Contract #: 04-0120F4Cty: SF/ALA Rte: 80 PM: 13.2/13.9File #: 69.25B**QUALITY ASSURANCE -- NON-CONFORMANCE REPORT****Location:** Changxing Island, Shanghai, P.R. China**Report No:** NCR-000752**Prime Contractor:** American Bridge/Fluor Enterprises, a JV**Date:** 31-May-2010**Submitting Contractor:** Zhenhua Port Machinery Company, Ltd (ZPMC), Changxing Island**NCR #:** ZPMC-0715**Type of problem:****Welding****Concrete****Other****Welding****Curing****Procedural****Bridge No:** 34-0006**Joint fit-up****Coating****Other****Component:** Suspender Brackets for OBG Lift 7**Procedural****Procedural****Description:****Reference Description:** ZPMC performed repair not in conformance with the approved CWRs**Description of Non-Conformance:**

**Dear:** Mr. Charles Kanapicki  
**Job Name:** SAS Superstructure

**Subject:** NCR No. ZPMC-0715

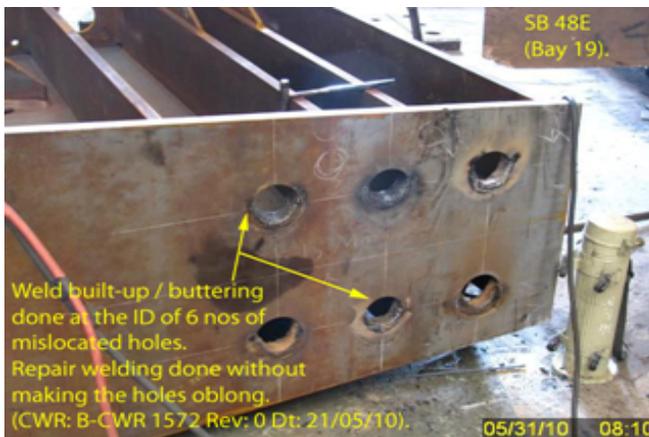
-ZPMC welding personnel performing base metal restoration of the mis-located suspender rod holes on suspender bracket identified as SB48E.

-The repairs did not comply with the approved Critical Welding Report (CWR): B-CWR1572 and B-CWR1578.

-ZPMC welder was buttering (build up with weld) the cross-sectional surface along the full circumference of the mis-drilled holes.

-This manner of repair appears to have been performed on all 6 suspender rod holes on the following suspender brackets: SB48E (Segment 7AE), SB48W (Segment 7AW), and SB54W (Segment 7CW).

The original buttering that was noted in the NCR was performed without Engineer's approval. A CWR was submitted after the fact and the disposition of this CWR stated that the repair would be performed in accordance with Submittal #200. However, the work as it was actually performed was not in accordance with this. The buttered weld material added needs to be removed and replaced in accordance with Submittal #200R3. It is not necessary to completely fill the holes but edges need to be beveled and NDT performed prior to redrilling the holes.

ZPMC performed buttering and will re-boring to fix the axiality issue. (Beveling was not necessary for the building up of edges as the holes are big enough.) 100% UT & MT will be performed after welding to warrant the soundness of the buttering welds. Notification for NDT cross-check will be sent to department's inspector prior to re-boring.

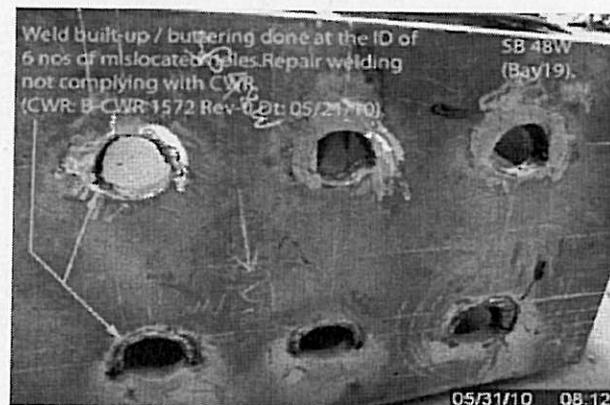
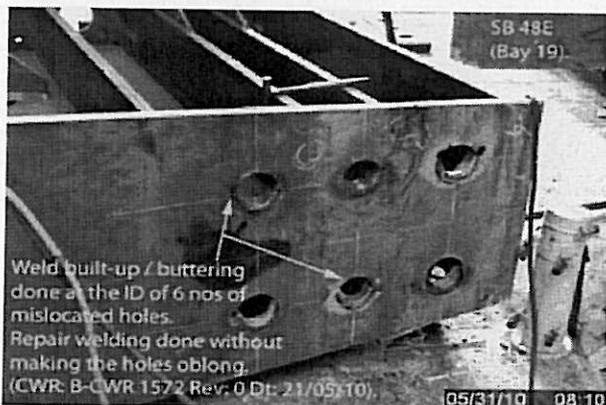
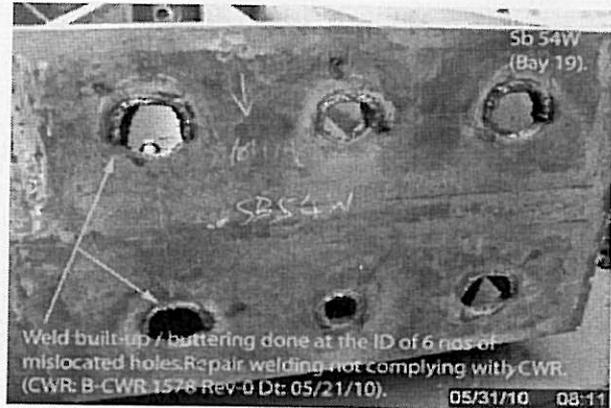
-ZPMC welding personnel performing base metal restoration of the mis-located suspender rod holes on suspender bracket identified as SB48E.

-The repairs did not comply with the approved Critical Welding Report (CWR): B-CWR1572 and B-CWR1578.

-ZPMC welder was buttering (build up with weld) the cross-sectional surface along the full circumference of the mis-drilled holes.

-This manner of repair appears to have been performed on all 6 suspender rod holes on the following suspender brackets: SB48E (Segment 7AE), SB48W (Segment 7AW), and SB54W (Segment 7CW).

This NCR pertains to a welding issue not a fit up issue. The repair was not performed in conformance with the approved CWRs. Corrective actions and preventive measures are required to close this NCR.

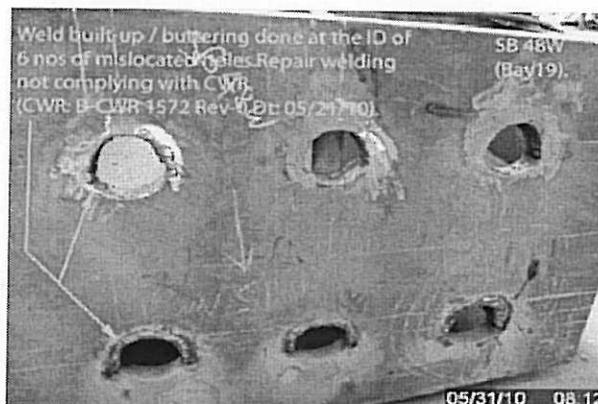
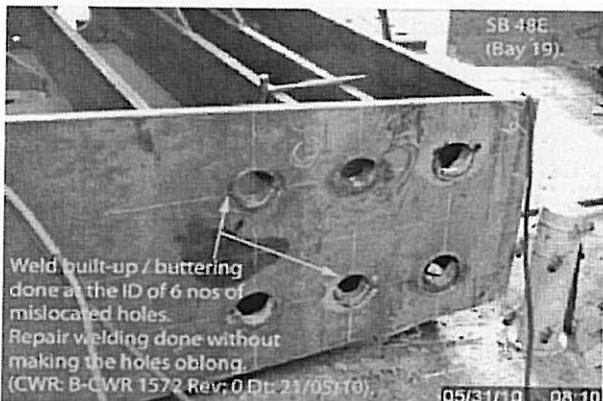
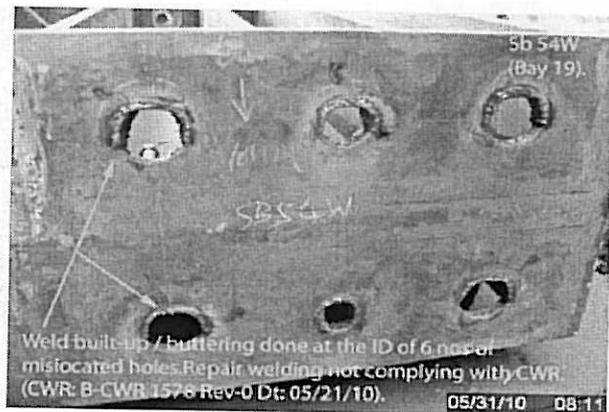
-ZPMC welding personnel performing base metal restoration of the mis-located suspender rod holes on suspender bracket identified as SB48E.

-The repairs did not comply with the approved Critical Welding Report (CWR): B-CWR1572 and B-CWR1578.

-ZPMC welder was buttering (build up with weld) the cross-sectional surface along the full circumference of the mis-drilled holes.

-This manner of repair appears to have been performed on all 6 suspender rod holes on the following suspender brackets: SB48E (Segment 7AE), SB48W (Segment 7AW), and SB54W (Segment 7CW).

The proposed resolution is acceptable. This NCR is considered closed.
